Addendum 3  
TFM-028-26 – TA-511-25 ACADEMIC TUNNELS RE-WATERPROOFING CP-2 (Paton College Tunnels)

- .2 The Date of the Addendum is Friday, April 24, 2026

PROJECT NAME:  
**ACADEMIC TUNNELS  
 RE-WATERPROOFING (PATON  
 COLLEGE TUNNELS) CP-2**  
 Project #: TA-511-25

DRAWING TITLE:  
**PATON COLLEGE TUNNELS  
 DEMOLITION SITE PLANS**

PATON COLLEGE TUNNELS DEMOLITION PLAN  
 SCALE: 1:250

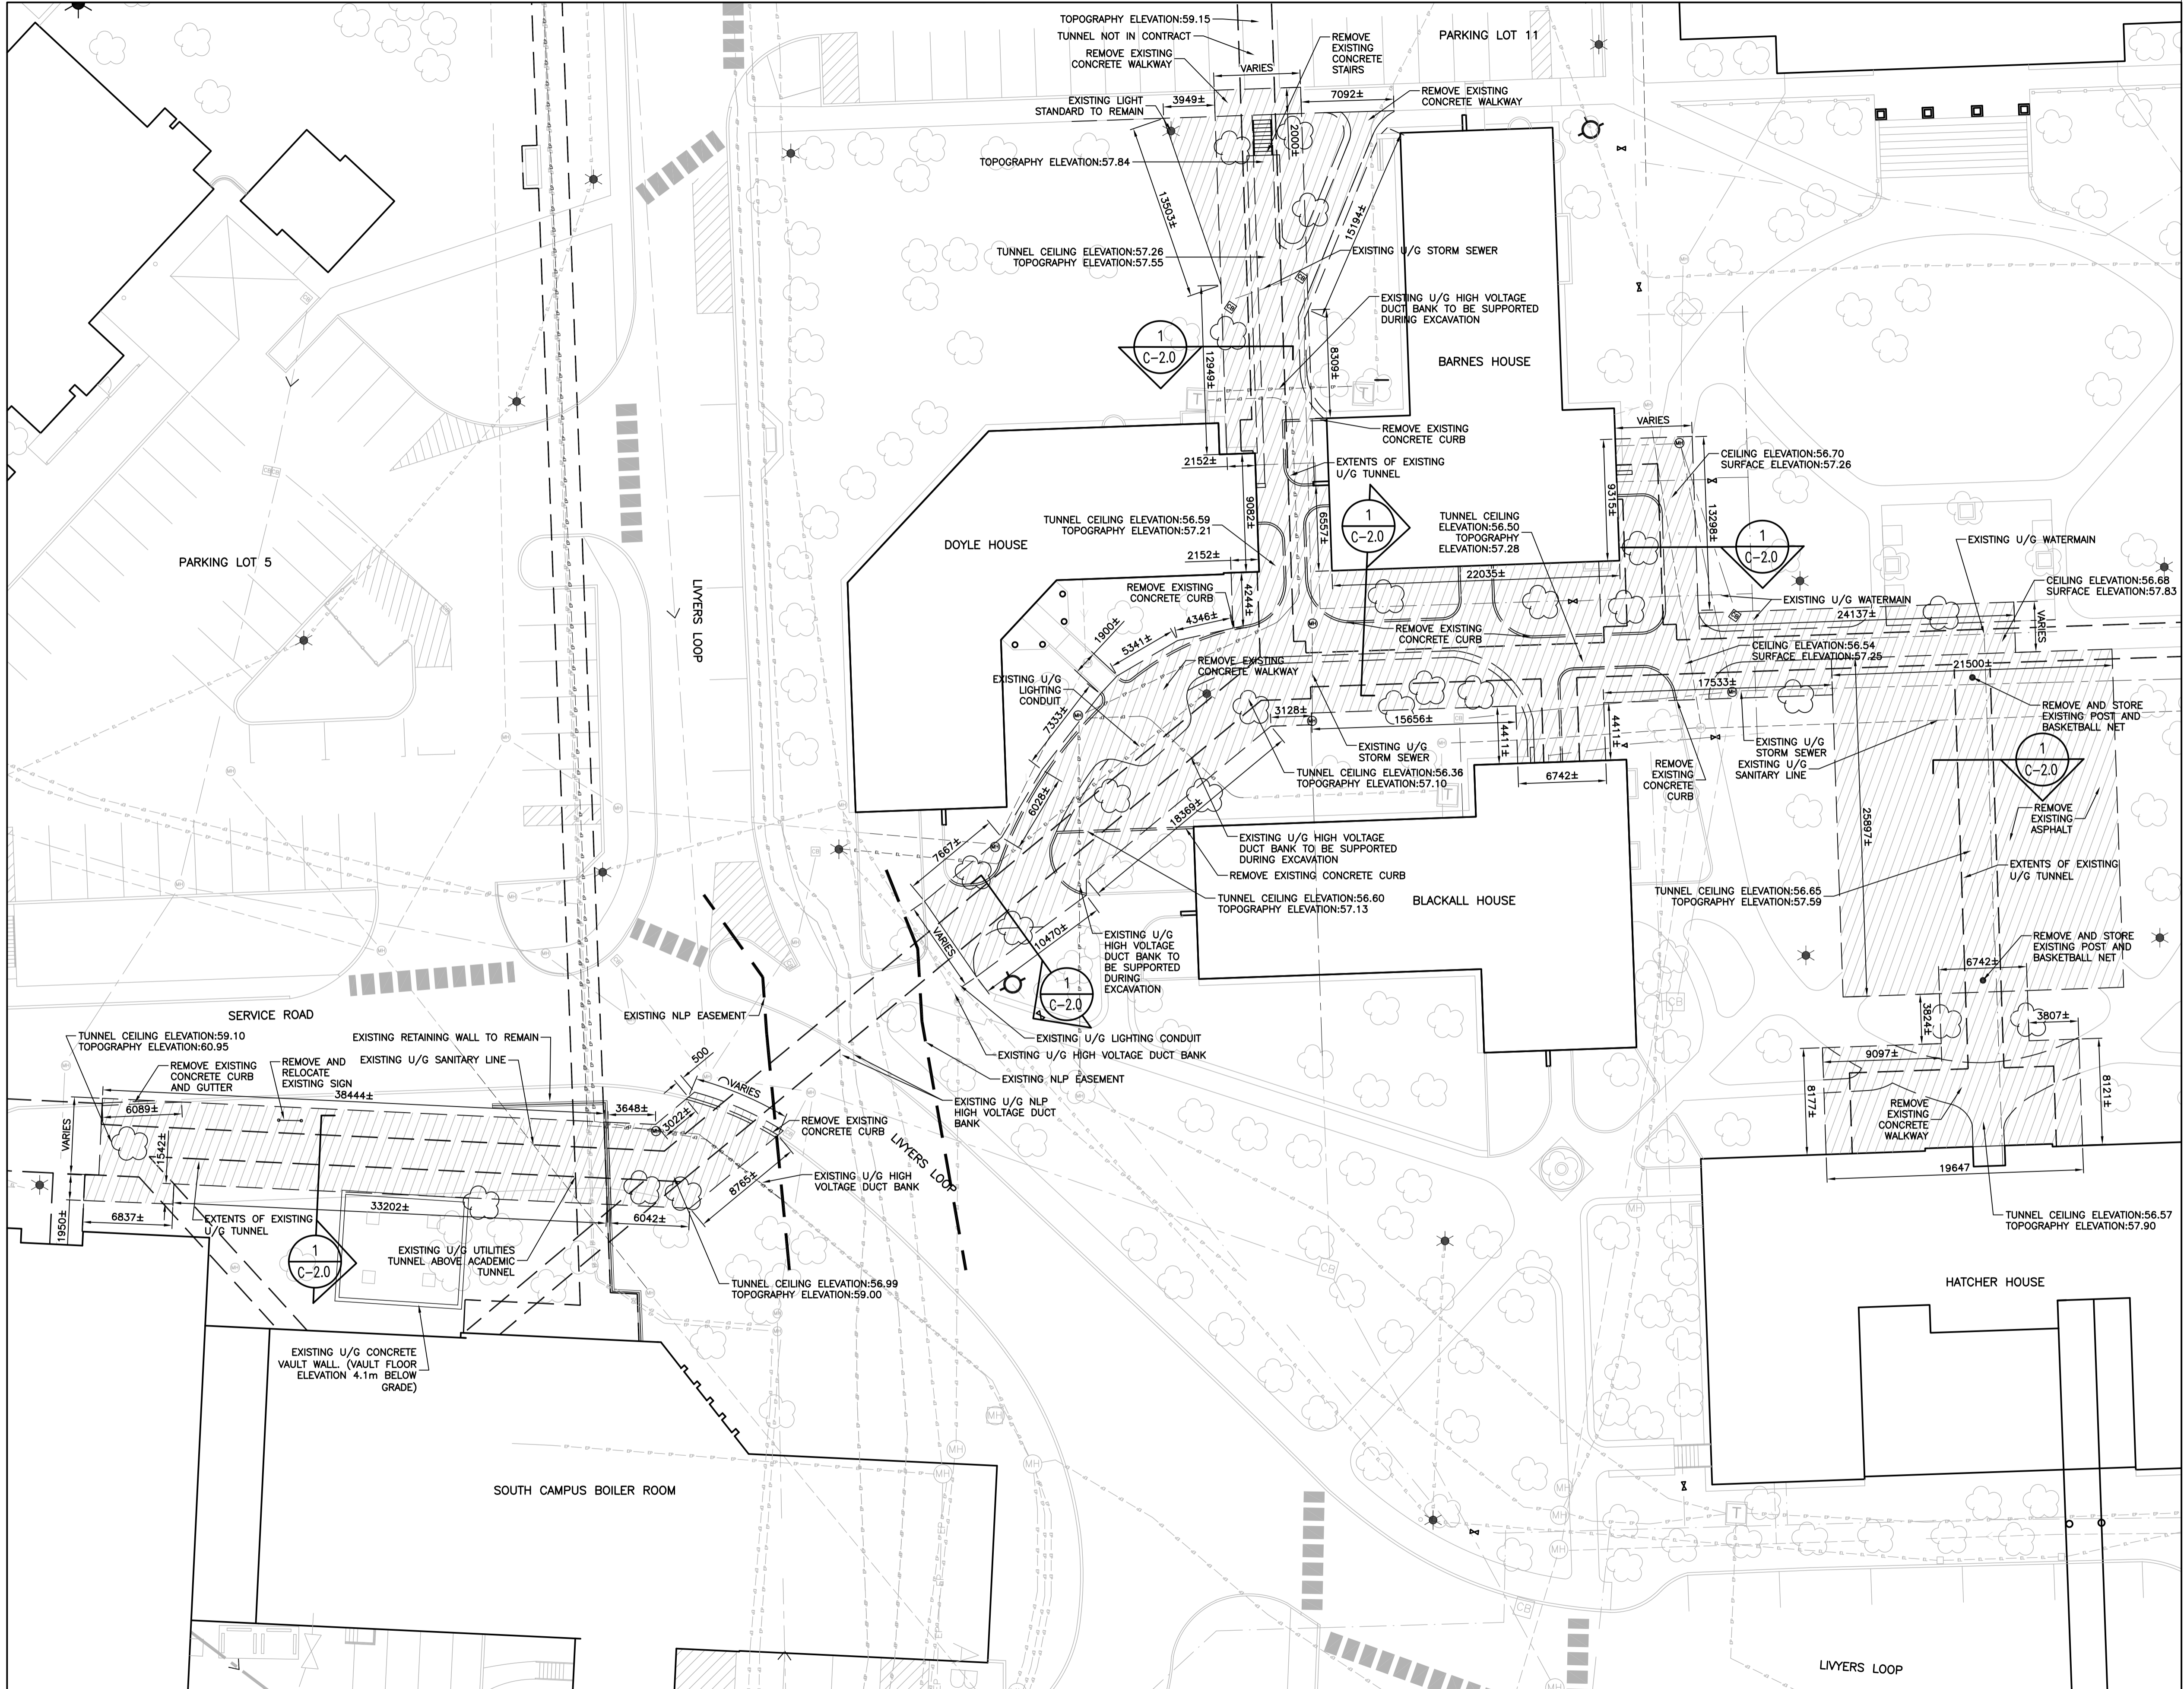
1. Drawing 1/C-1.1 Paton College Tunnels Demolition Plan
1. Modification on the drawing to display a underground vault behind the South Campus Boiler Room that was not on original drawings.

2. **Question:** The area of tunnel below Livyer's Loop appears to be omitted from the waterproofing replacement limits. The hatching for remove and replace waterproofing then starts again at the curb line. Is the termination of waterproofing as shown on the drawings, or will adequate setback be decided in the field to ensure that additional reinstatements are not required in roadways due to the sloping required to expose the waterproofing to the termination limits shown on the drawings?

**Answer:** The removal area indicated on the drawings along with dimensions are the limits of this project. You will notice that "varies" is indicated on the drawings for the width because the depth will change. The road in that area is not included in the contract due to an underground NLP high voltage duct bank and corresponding easement as noted in the drawings.

DESIGNED:	S.C	DRAWN:	S.C
REVIEWED:	J.A	APPROVED:	E.H
SCALE:	AS SHOWN	DATE:	APRIL, 2026
PROJECT No.	TA-511-25	DRAWING No.	C-2.0

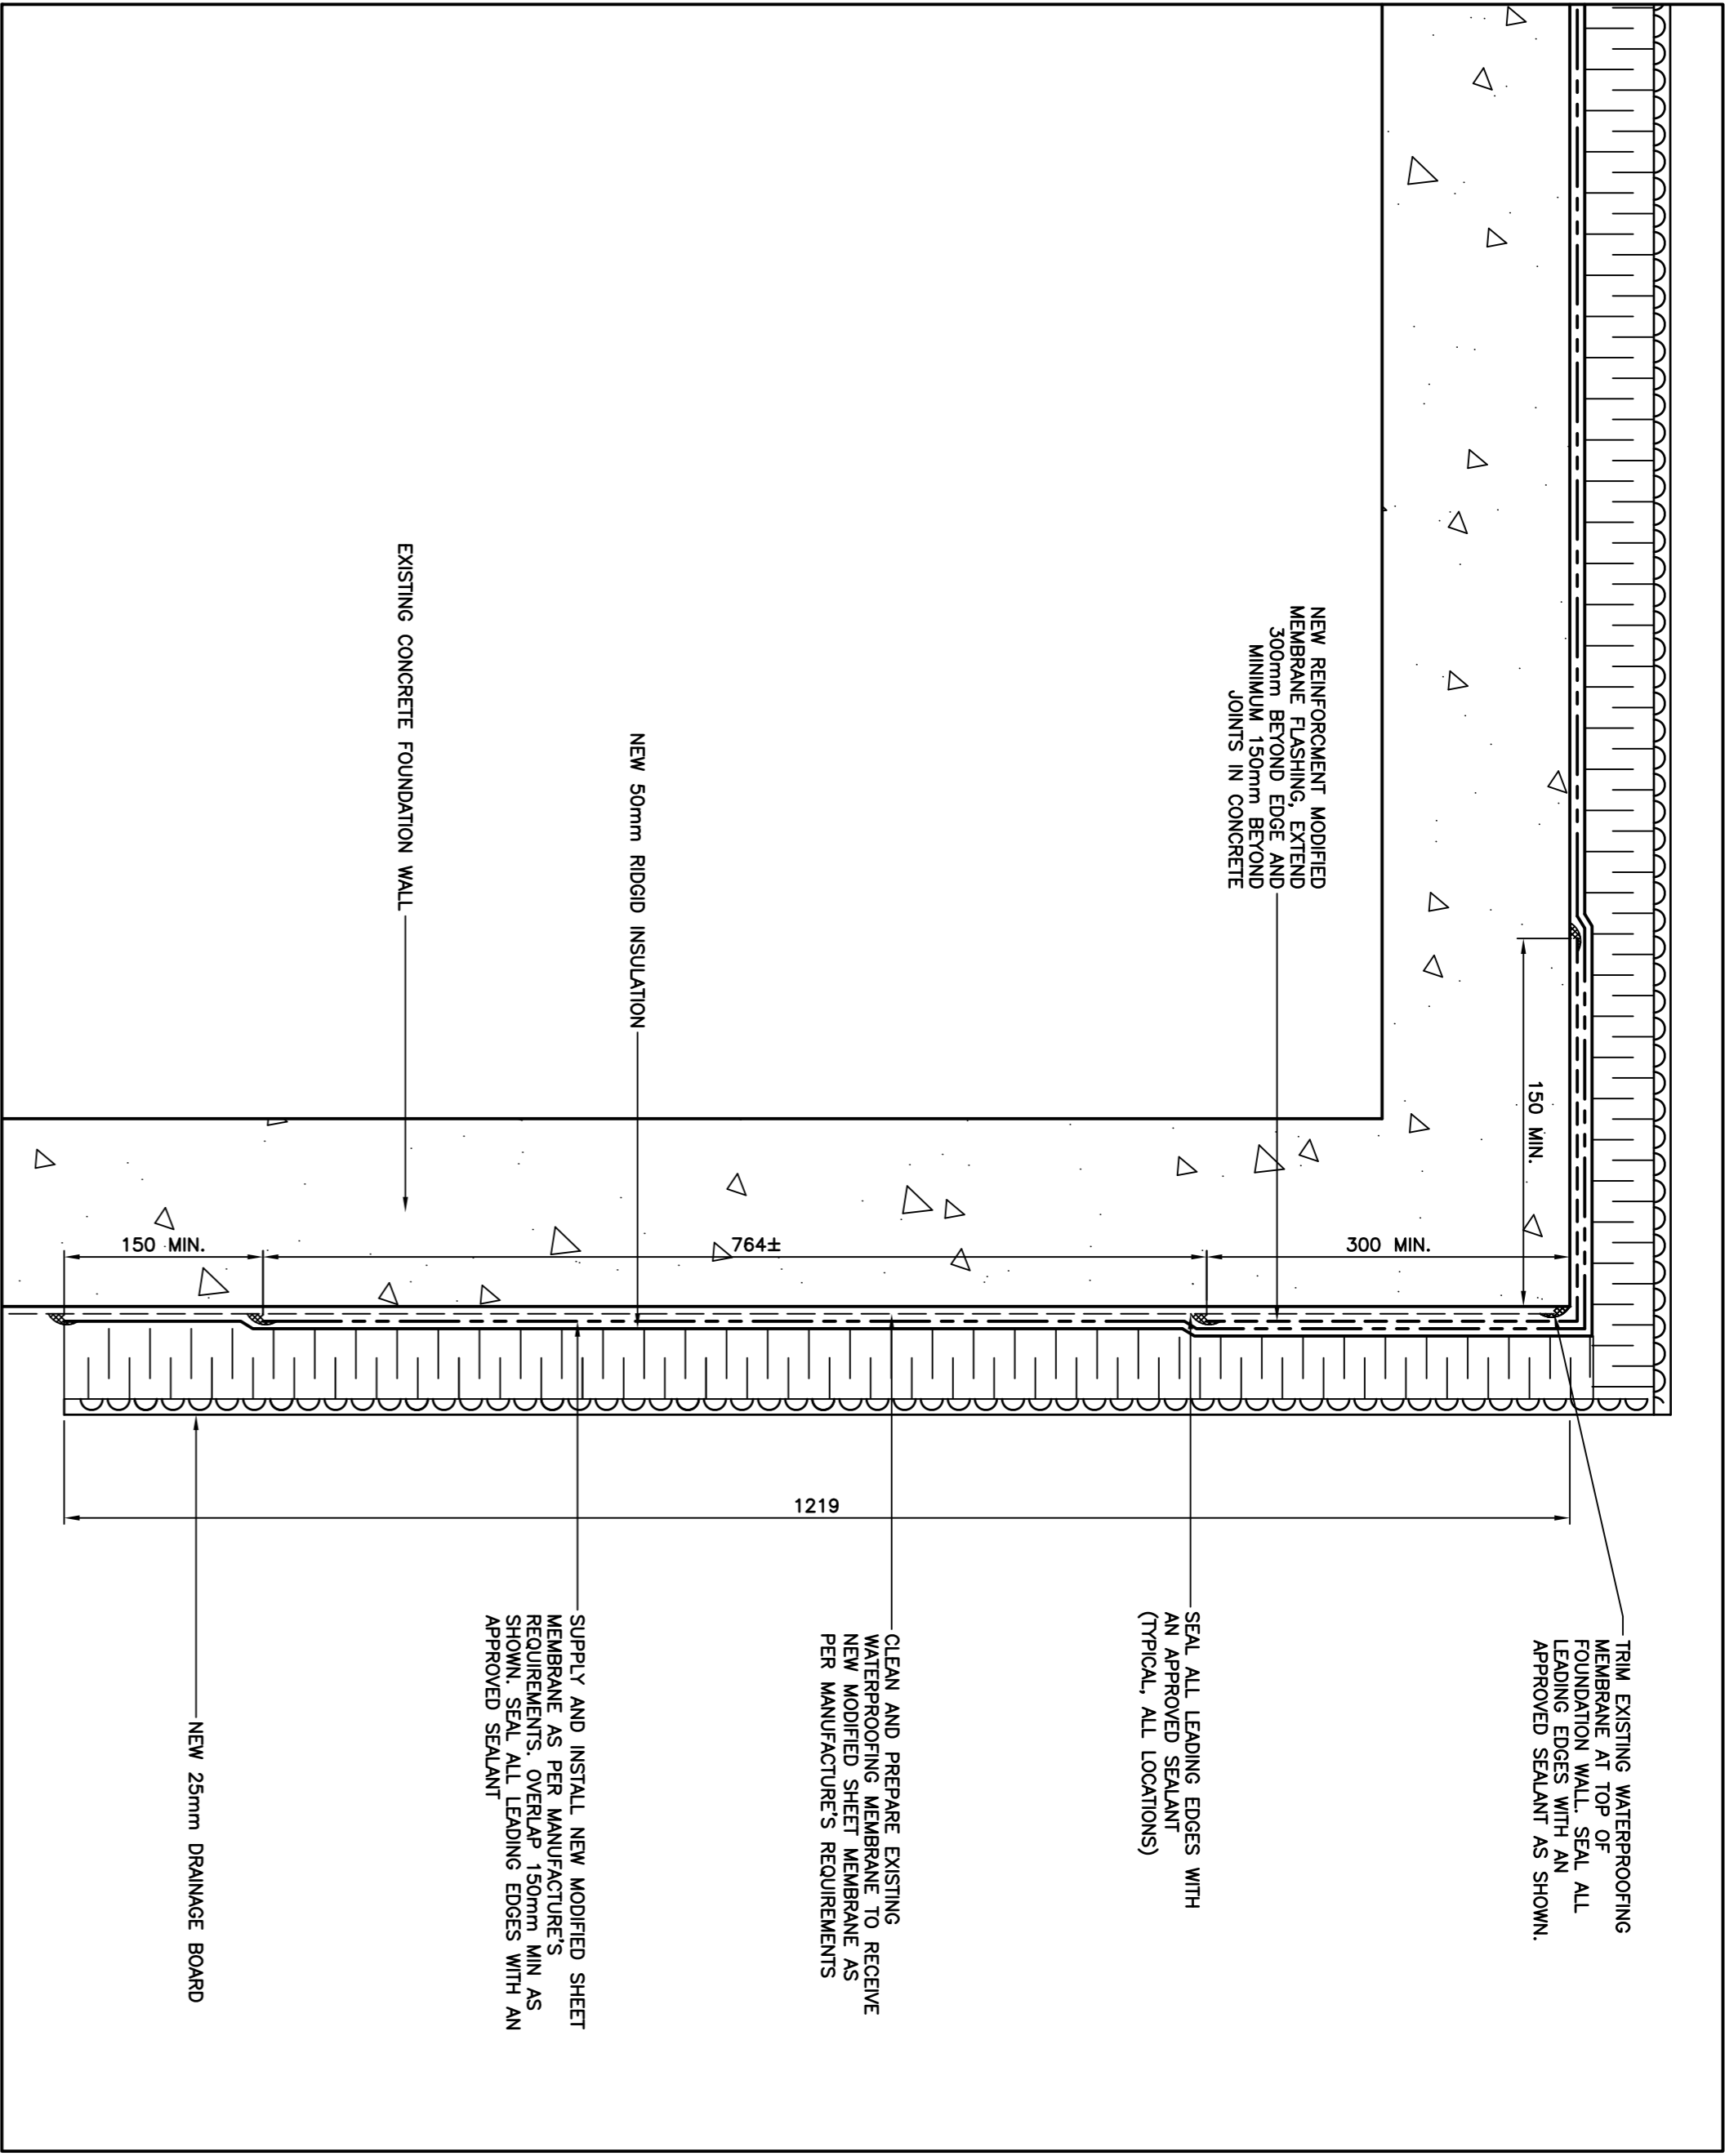
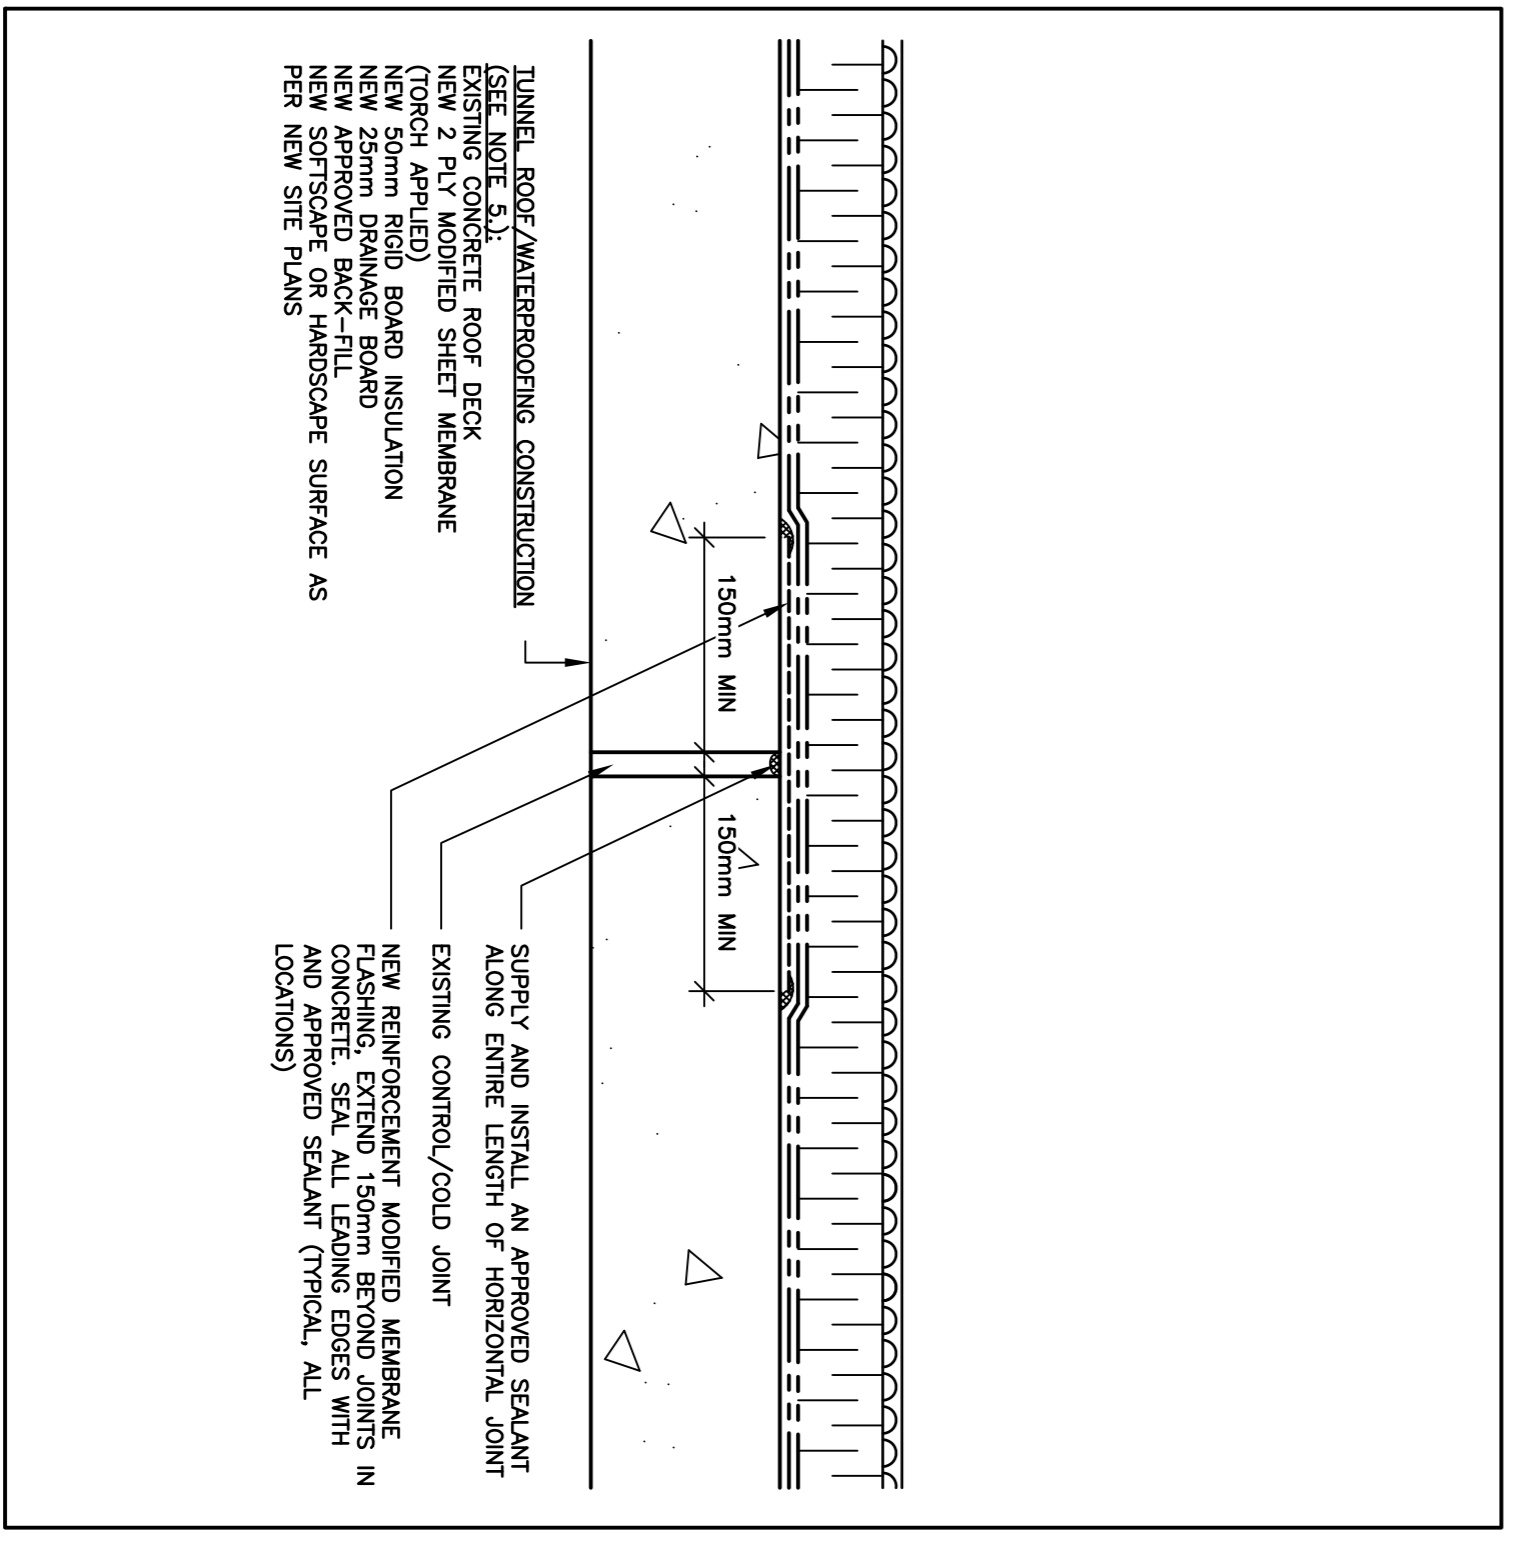
6. **Question:** Details 3/C-2.0 and 5/C-2.0 show that 2.0% tapered insulation should be installed at the roof/wall intersections and at the control/cold joints. However, the extents of where tapered insulation is required is unclear. Would it be possible to issue a revised drawing or other means of clarification to indicate the tapered insulation areas?

**Answer:** The note in question was removed in Addendum #1
